HISTORIC AND DESIGN REVIEW COMMISSION

HDRC CASE NO: 2024-423
ADDRESS: 801 N OLIVE ST
701 NOLAN ST
LEGAL DESCRIPTION: NCB 539 (DIGNOWITY LOCKWOOD PARK), BLOCK 1 LOT 1
ZONING: RM-4, H
CITY COUNCIL DIST.: 2
DISTRICT: Dignowity Hill Historic District
APPLICANT: Leah Gundrum/TBG Partners
OWNER: Sean Duncan/CITY OF SAN ANTONIO
TYPE OF WORK: Park Improvements
APPLICATION RECEIVED: December 20, 2024
60-DAY REVIEW: February 18, 2025
CASE MANAGER: Rachel Rettaliata

The applicant is requesting a Certificate of Appropriateness to complete park improvements in Dignowity/Lockwood Park including:

sheet title
water feature
enlargement

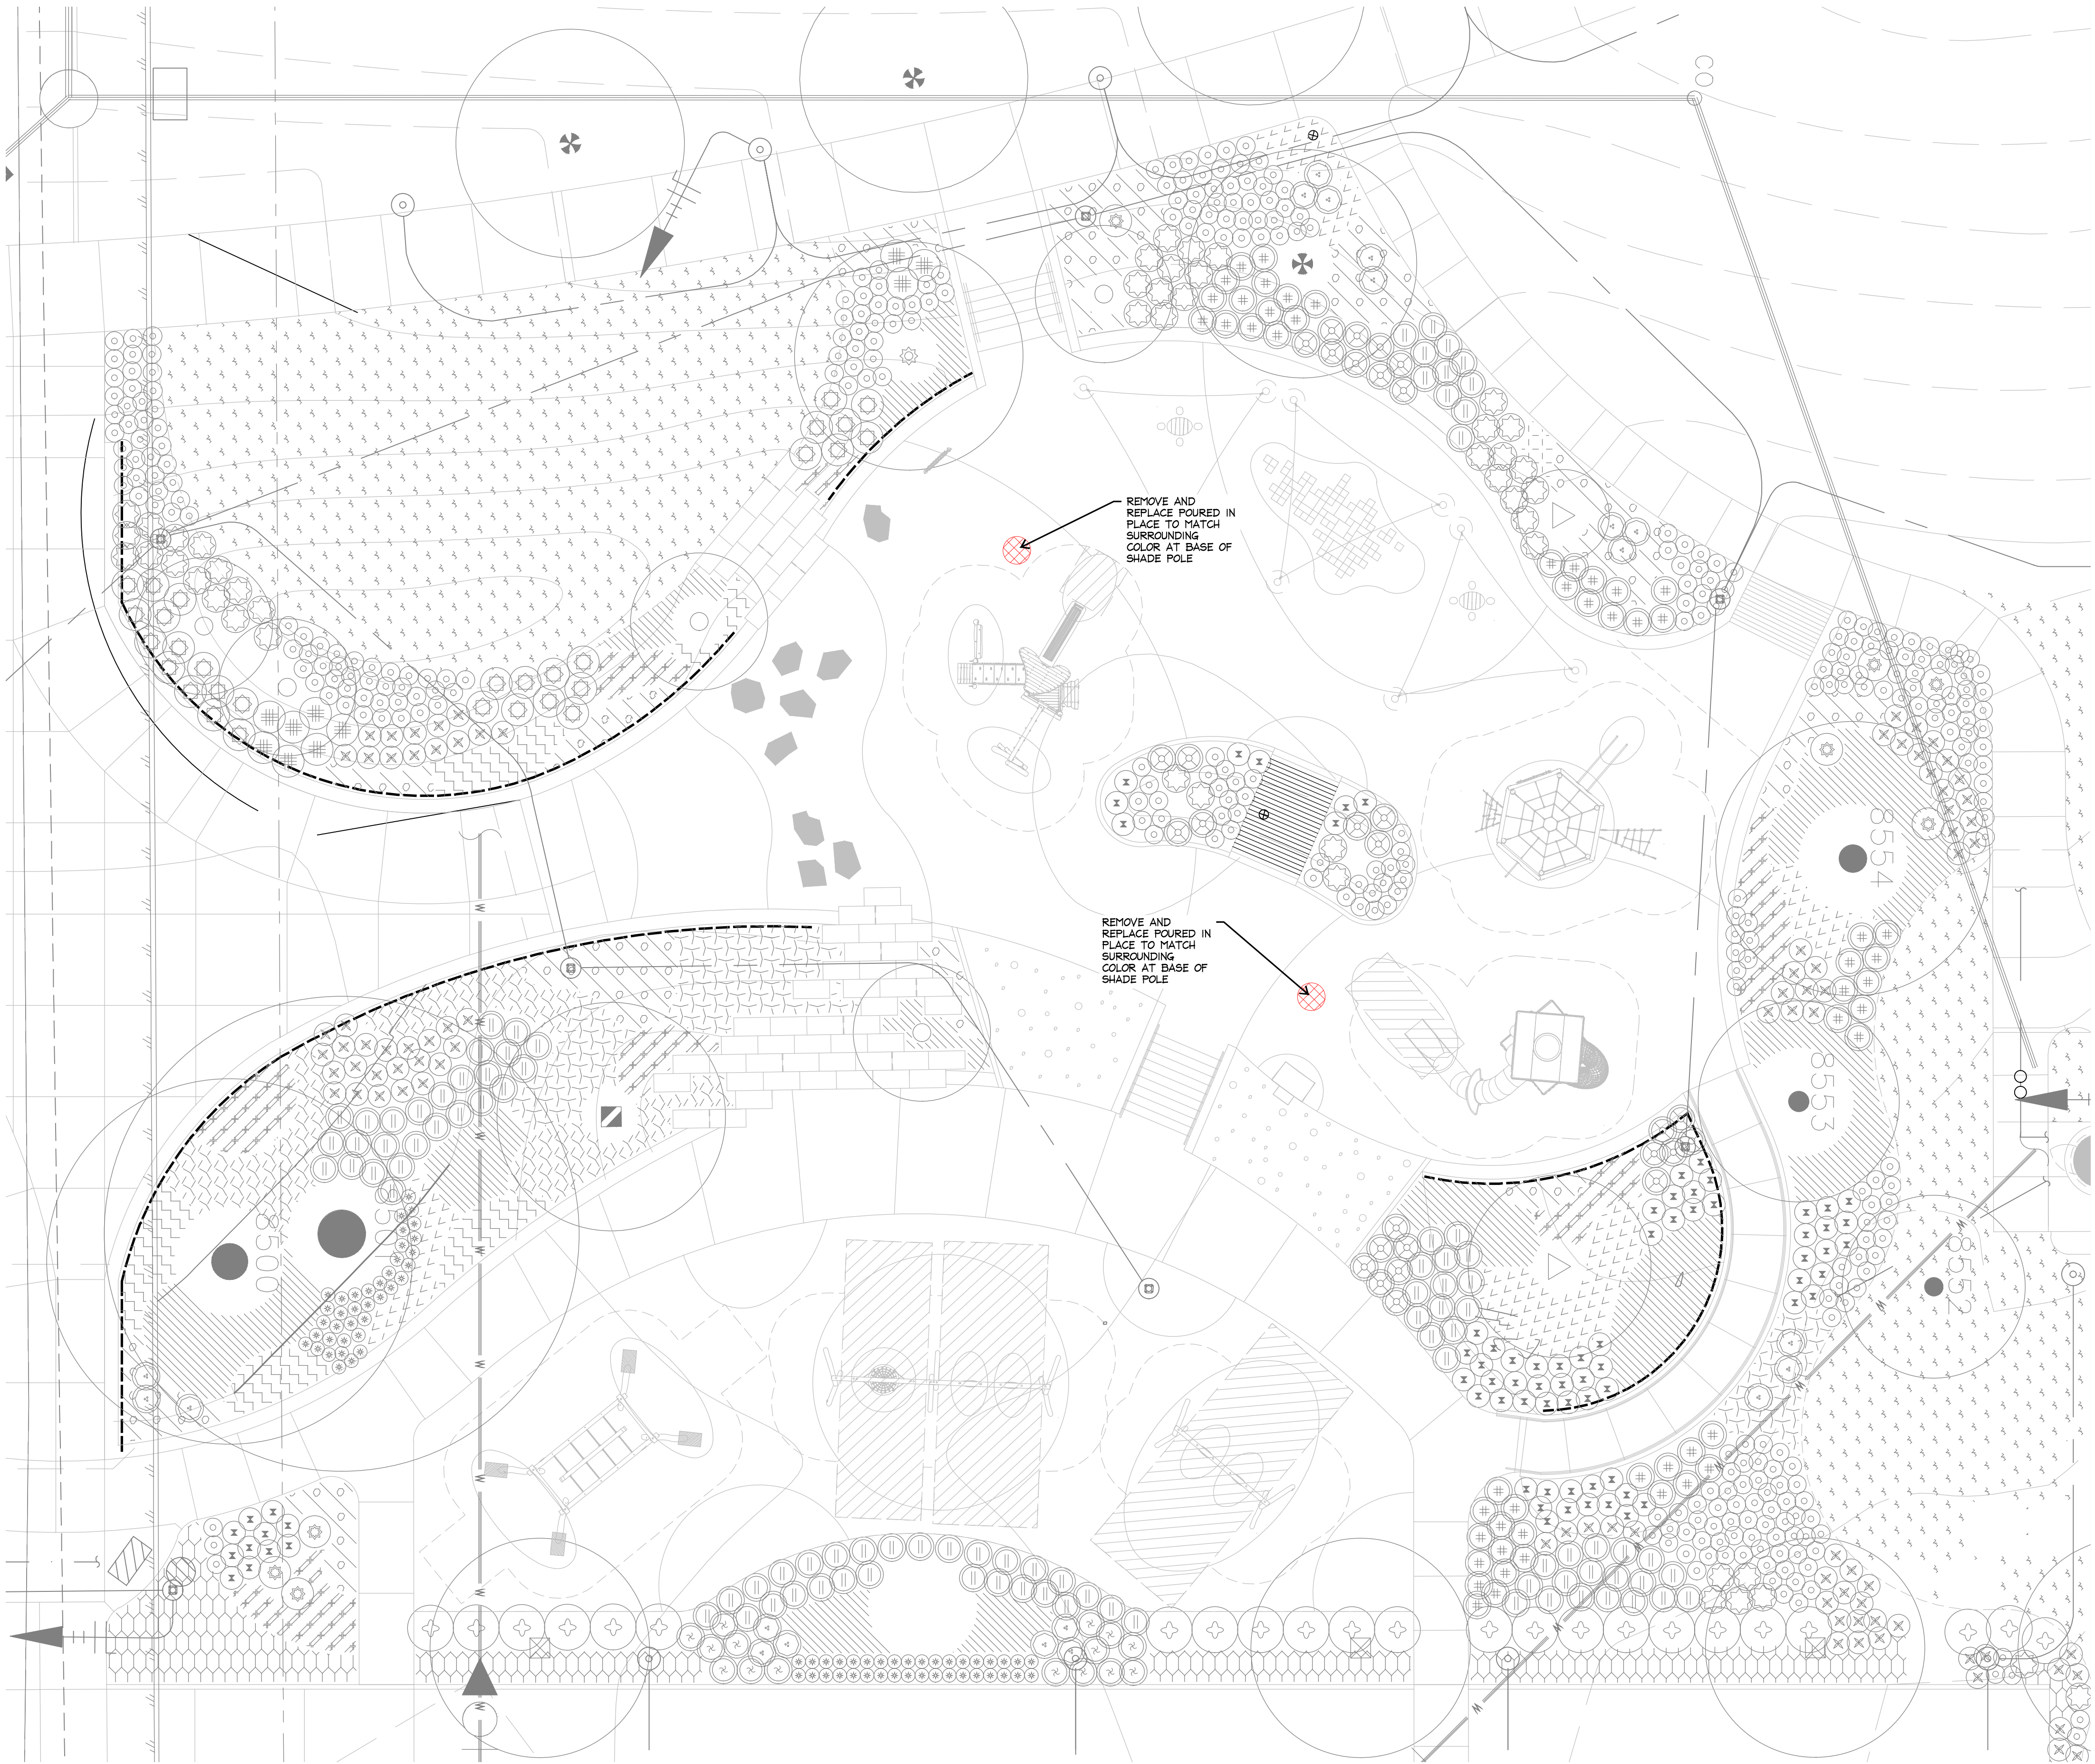
- b. **WATER FEATURE INSTALLATION** – The applicant has proposed to install an interactive water feature near the center of the park, at the central plaza, south of the Burnet Street walkway through the park. The installation of the proposed water feature will require the demolition and removal of existing concrete and aggregate in the proposed location. The area of work will not impact the existing 1-story stone structure on the west side of the curved north-south pedestrian walkway. The proposed water feature will feature a specialty integral color concrete with a sandblast finish, a decorative trench drain, and nozzles at grade to create a splash pad. The new concrete surfacing will feature a 4-foot-wide sloped area to move water away from the splash pad and to

prevent standing water. The installation of the water feature will require the installation of a proposed 96-inch tall, 150-square-foot cabinet directly west of the existing 1-story stone structure, and a below-ground 6,000-gallon holding tank. The water feature area will also feature four (4) GOBO LED projector light fixtures to an existing pole located to the northeast of the proposed splash pad, and four (4) GOBO LED projector light fixtures on a new pole with a concrete footing to the south of the proposed splash pad to create an interactive element for the splash pad. The water feature will only be operable during pre-set park hours. Staff finds the proposal generally consistent with the Unified Development Code (UDC).

Staff recommends approval based on findings a through e with the following stipulation:

sheet title
playground
shade
enlargement

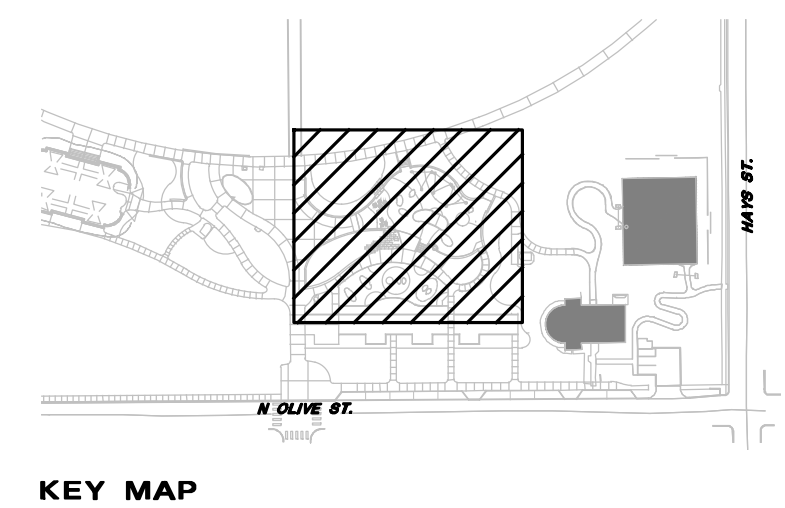
- c. SHADE STRUCTURE INSTALLATION – The applicant has proposed to install three (3) new single-post shade structures in the Lockwood/Dignowity Park. Two (2) of the new shade structures are proposed for installation at the playground, at each exit for the play structures. An additional shade sail structure is proposed at the proposed interactive water feature. The proposed shade structures are approximately 400 square feet and will not exceed 10'-5" in height. Staff finds the proposal generally appropriate.
